Title Modulebit_004.SchDoc		Cambridge Prototypes Ltd 2 Darnford Way Cambridge CB4 2DP
Size: A2	Number: 1	Revision: V0.4
Date: 10/31/2016	Time: 7:42:26 PM	Sheet 1 of 1
File: P:\Live_Projects\Microbit\V4\Modulebit_004.SchDoc

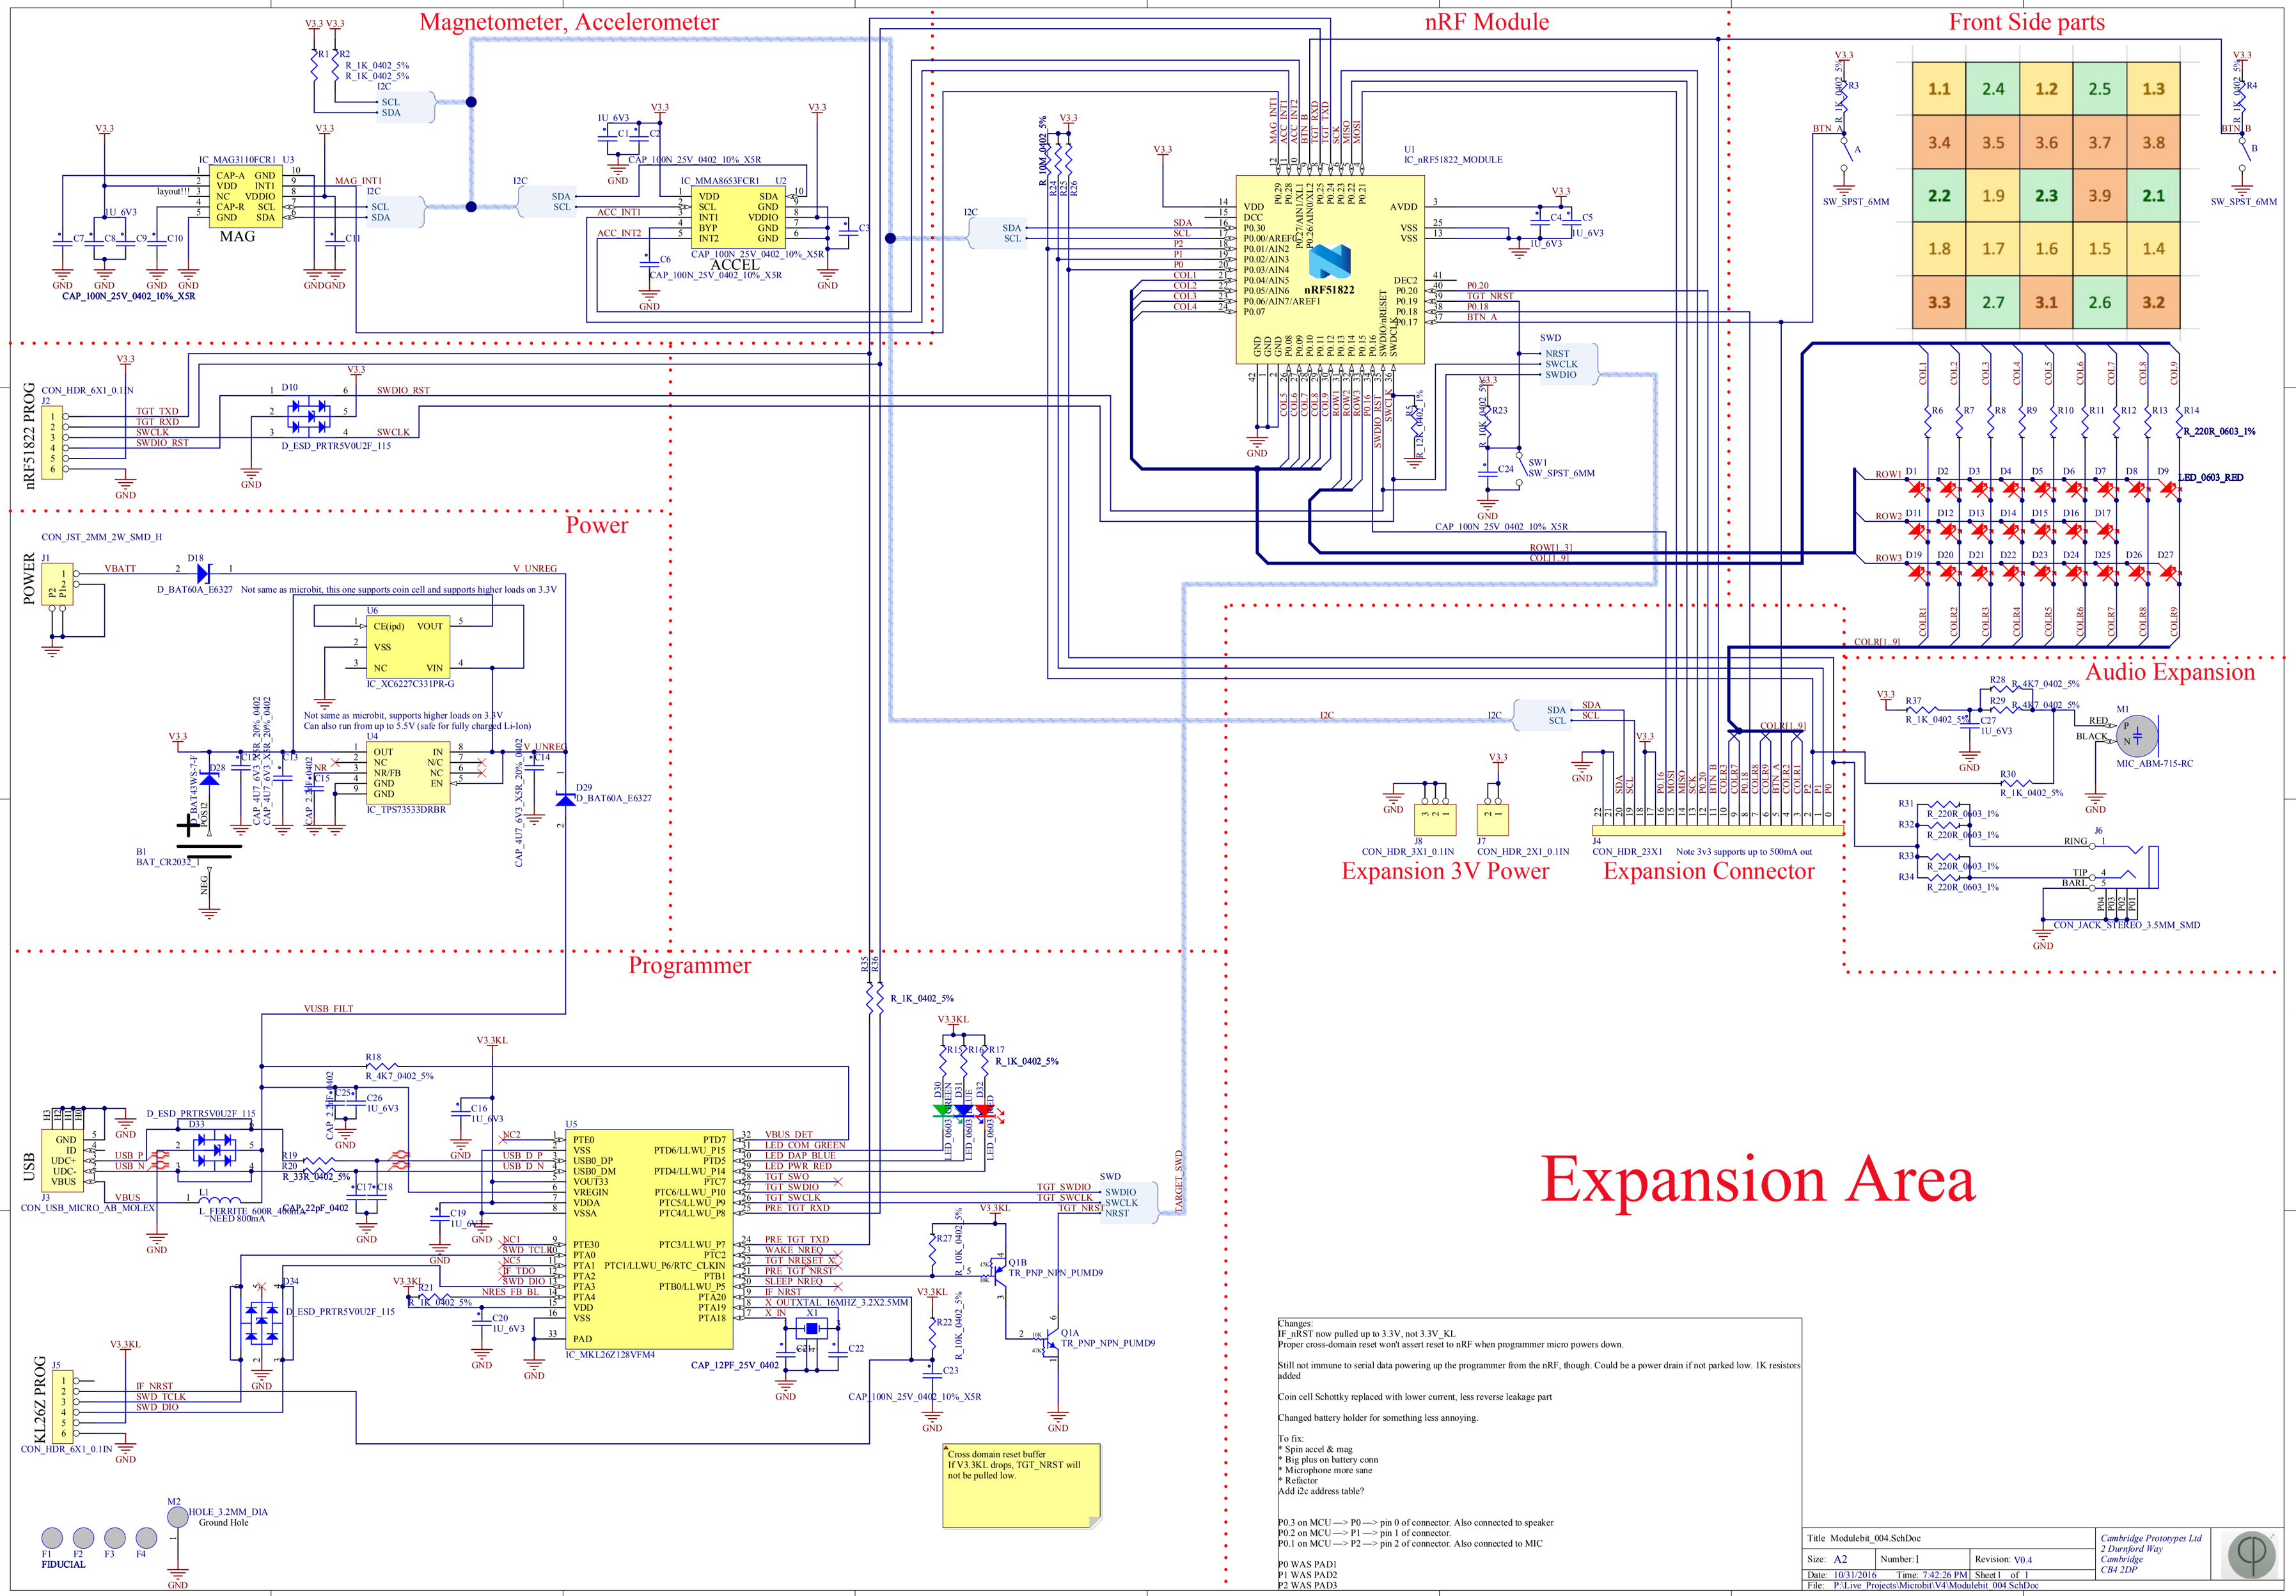
Changes:
IF_nRST now pulled up to 3.3V, not 3.3V_KL
Proper cross-domain reset won't assert reset to nRF when programmer micro powers down.

Still not immune to serial data powering up the programmer from the nRF, though. Could be a power drain if not parked low. 1K resistors added

Coin cell Schottky replaced with lower current, less reverse leakage part

Changed battery holder for something less annoying.

To fix:
* Spin accel & mag
* Big plus on battery conn
* Microphone more sane
* Refactor
Add i2c address table?

P0.3 on MCU —> P0 —> pin 0 of connector. Also connected to speaker
P0.2 on MCU —> P1 —> pin 1 of connector.
P0.1 on MCU —> P2 —> pin 2 of connector. Also connected to MIC

P0 WAS PAD1
P1 WAS PAD2
P2 WAS PAD3
